2301 7th Avenue  
DRB Response - REC Meeting #2  
Date: February 11, 2020  
SDCI Project Number: 3034280-LU

This package is in response to DRB comments from the September 24th, 2019 REC meeting with the goal of addressing all the comments and concerns from that meeting. The specific DRB comments and applicant responses are summarized on pages 4 and 5. Subsequently, each specific DRB comment has a response through graphics and text.

## DRB Guidance - SDCI notes of 09/24/2019 Rec. Meeting

## Summary of Applicant Response to DRB Guidelines

**DRB Guidance - 3. Podium Massing and Expression  
Alley Side Design Comparison**

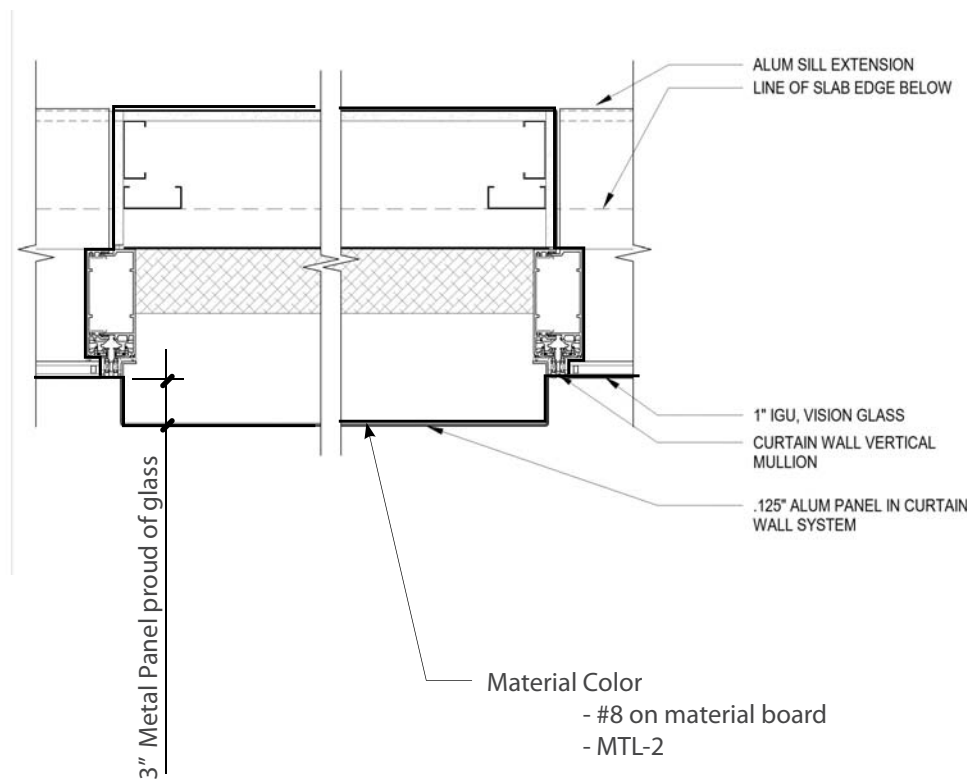
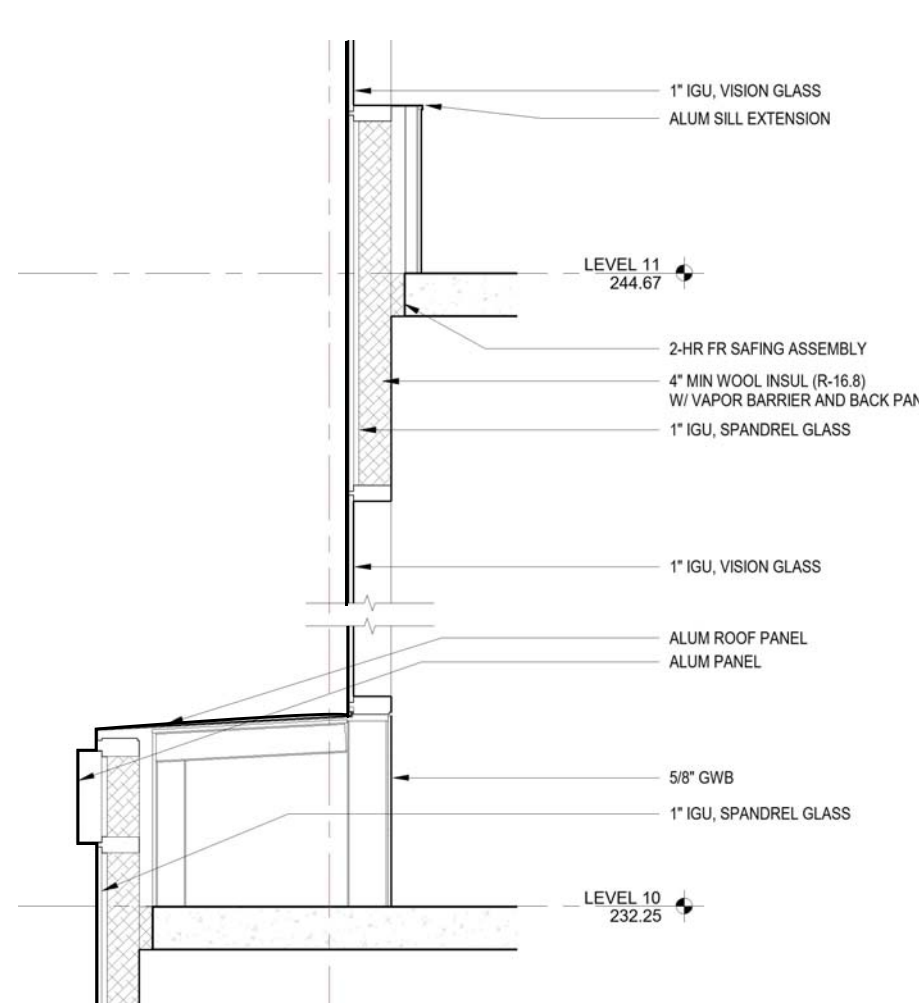
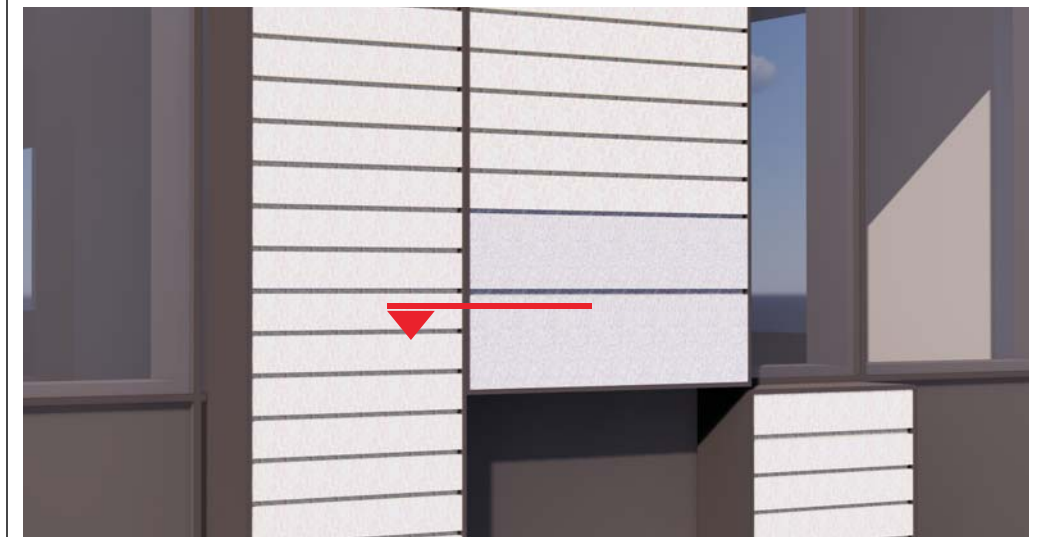
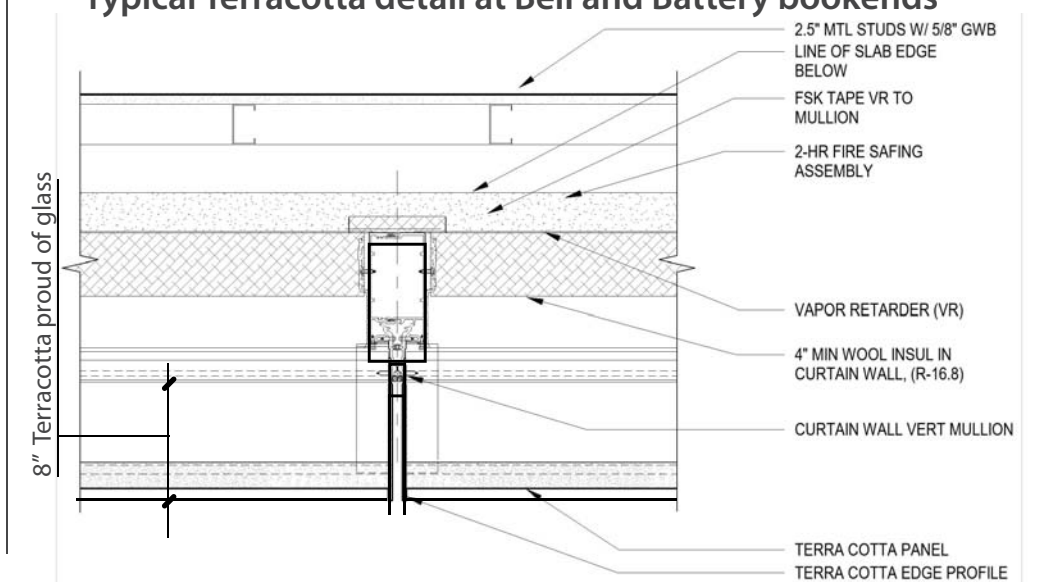
c. On the **Alley-Side**, reduction in number of **distinct expressions** diminished recognizable modulation. The Board recognized the unique character of **floor-to-ceiling glazing** from previously approved DRB design. Given program change, the applicant does not need to restore previous articulation but rather consider recomposing the alley facade to read as a collection of distinct element similar to the DRB approved design but not exactly. (B-4, C-2, C-6)

To reestablish more distinct expressions and create a better composition comparable to the previous MUP Approved Design, the applicant did the following:

- 6 • Mitigate podium impact by stepping podium in 4' at alley-side above 125'. (Removes approx. 1,900 s.f.)
- 2 • Increase terracotta detail at lower podium bookends and wrap around to alley-side. In addition, wrap stone from Bell Street residential entry to create garage entry portal.
- 4 • Add metal panel detailing between terracotta book ends to further break up the alley-side facade by adding an additional visual element to the composition.
- 7 • Break up alley facade into 5 distinct compositional elements, similar to Approved MUP design. (See pg. 16 for more detail)

**DRB Guidance - 3. Podium Massing and Expression**  
**Podium Break Down Study**

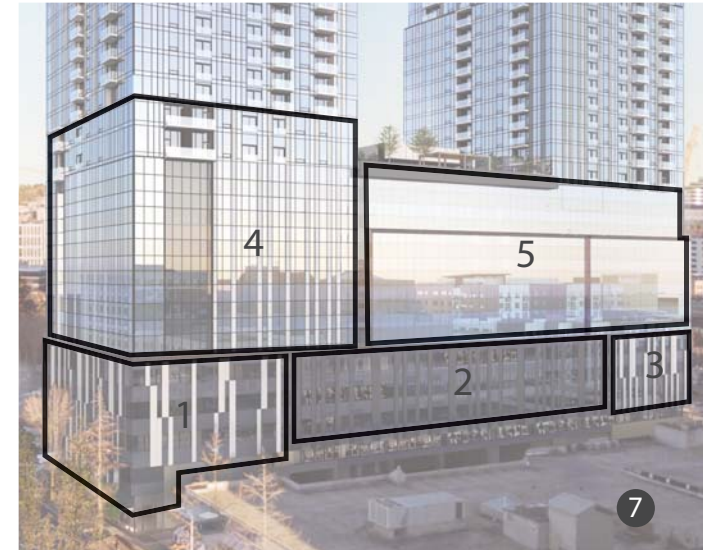
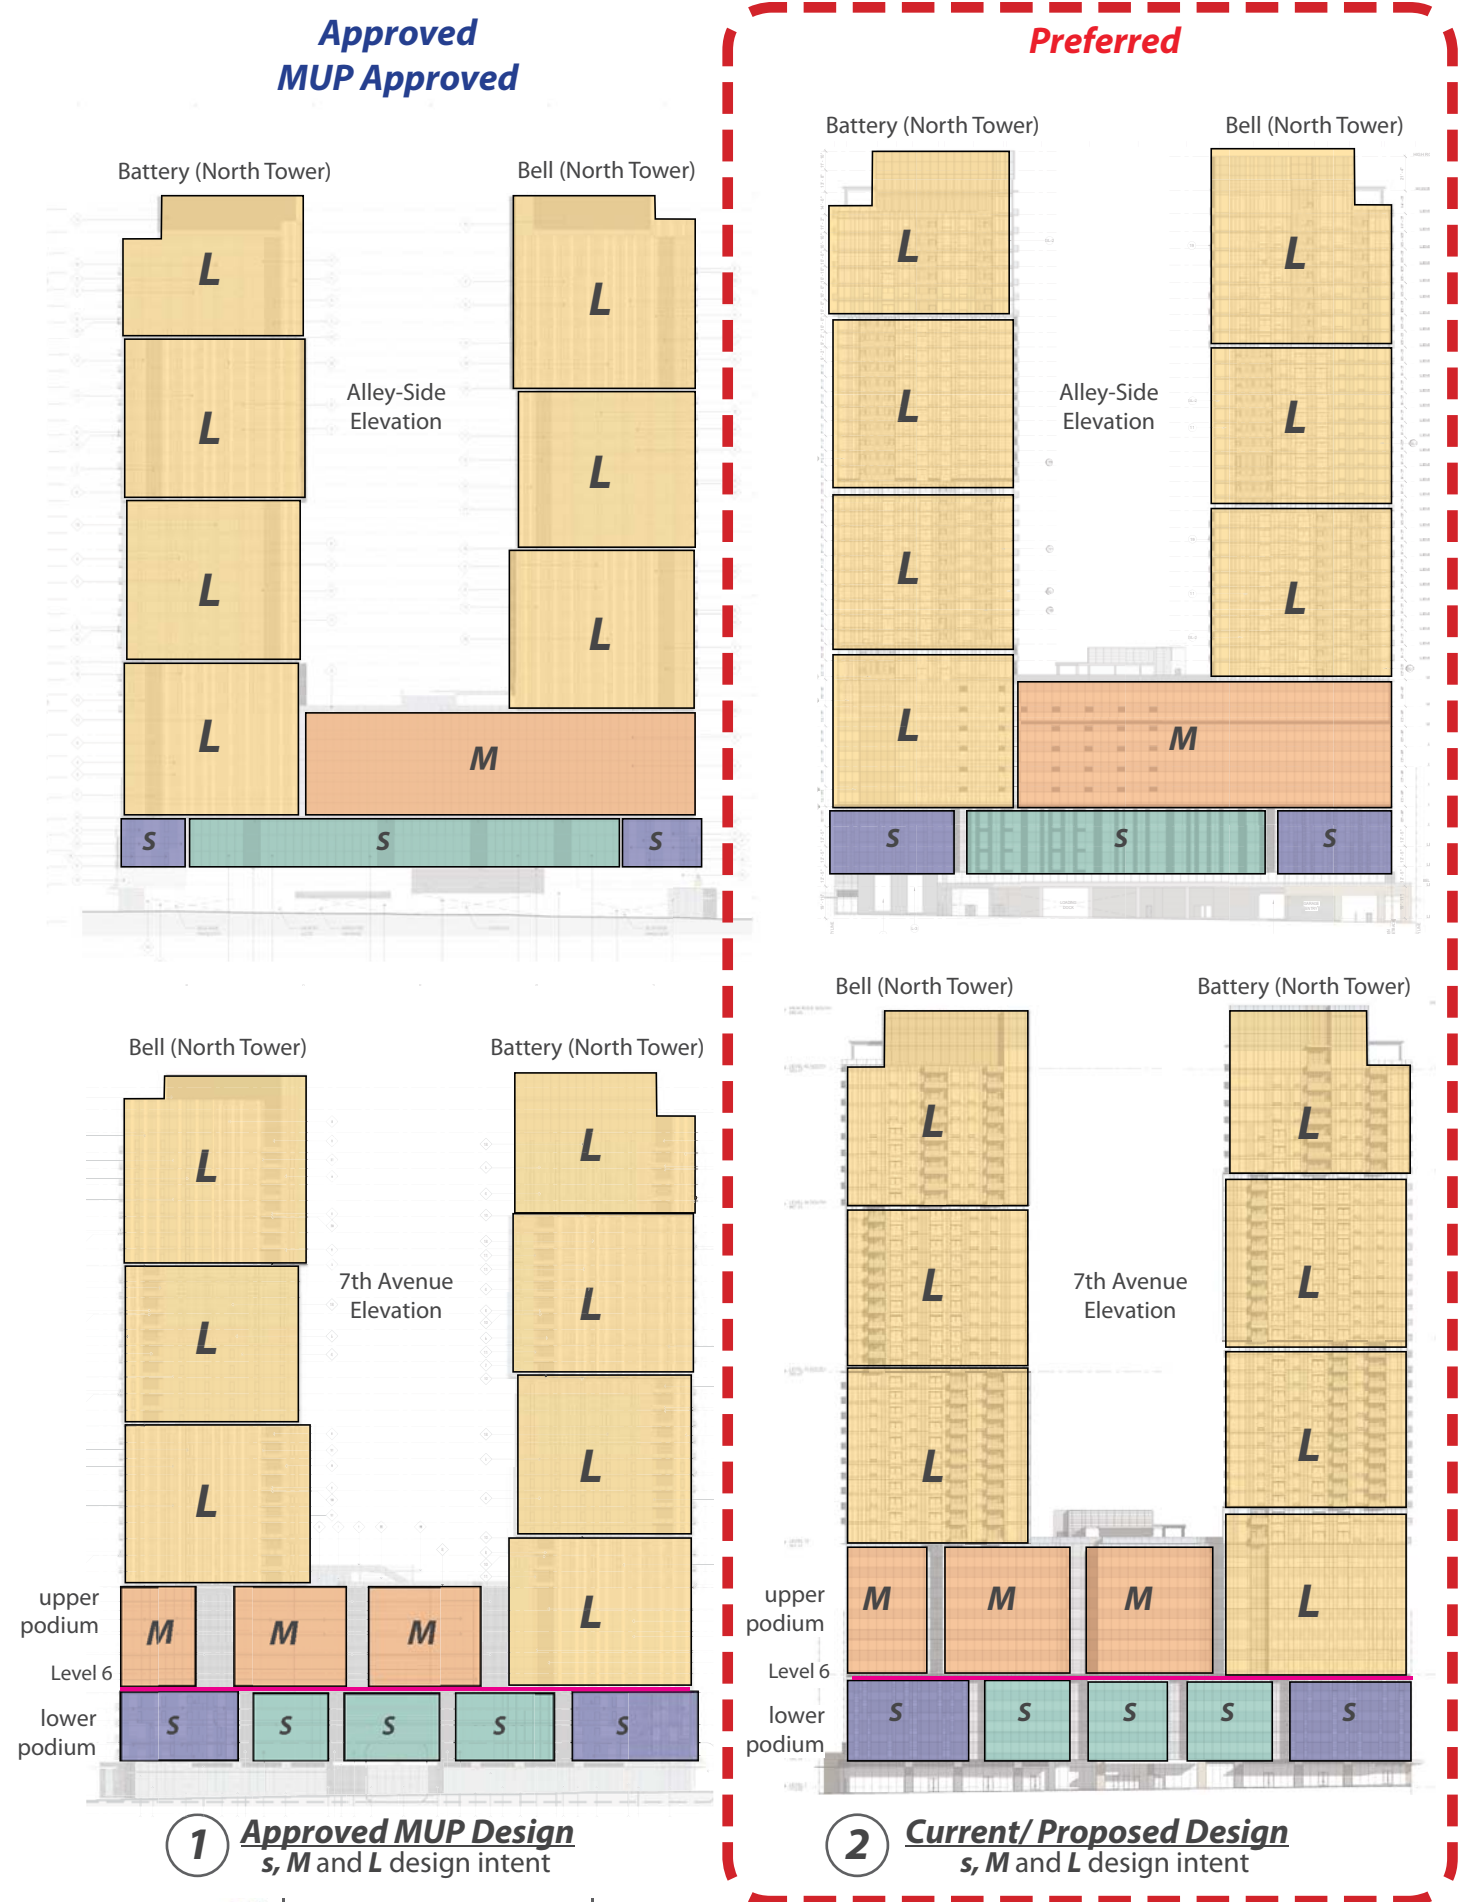
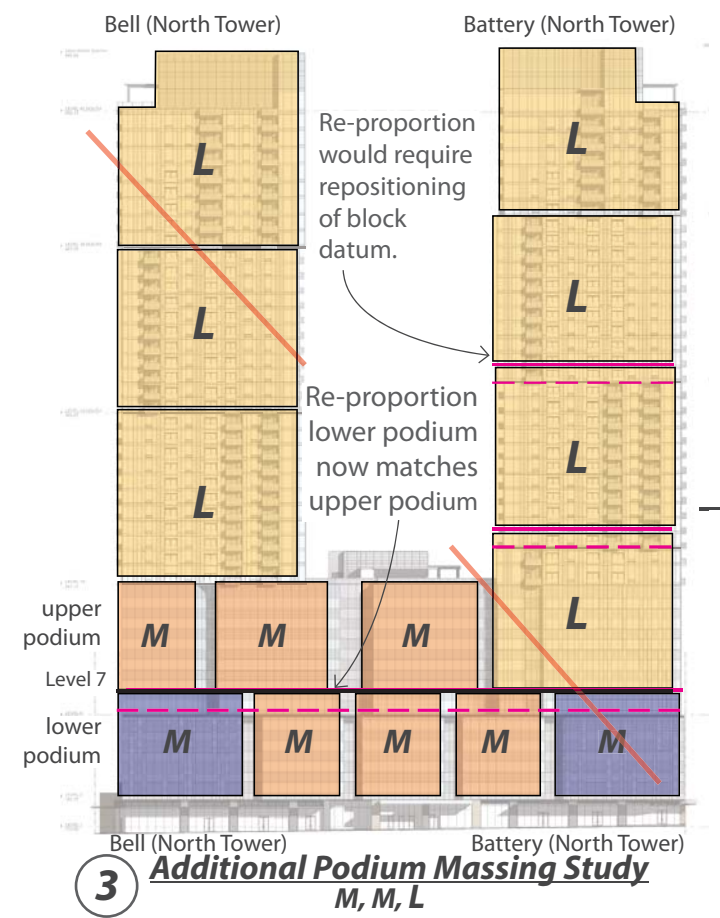
b. Successful aspects of the previously approved design was the relationship between the 'block' towers and the podium, and the **scale-mitigating** effect of the towers 'stepping' into the podium. Further development and articulation of the composition would be needed. (B-4, C-2)

Studies were done evaluating the Block towers and podium relationship through the lens of the already established **s, M, L** design concept. This concept was conceived in EDG and solidified in an already Approved MUP. The applicant feels strongly that "**s, M, L**" should continue as the organizing theme for this project regardless of the increased podium height. The concept successfully breaks the overall project down through modulations that establish the edges of the blocks/cubes that lessen in size as they get closer to the pedestrian level.

The facades of both the MUP approved and Proposed Designs have comparable compositions.

An additional study was done to determine whether raising the 85' datum line was beneficial to the project. It was determined that the elements used for the composition would be just **Medium** and **Large** blocks, not being consistent with the original conceptual design intent. In addition the overall blocks/cubes proportions for the lower podium become for vertical.
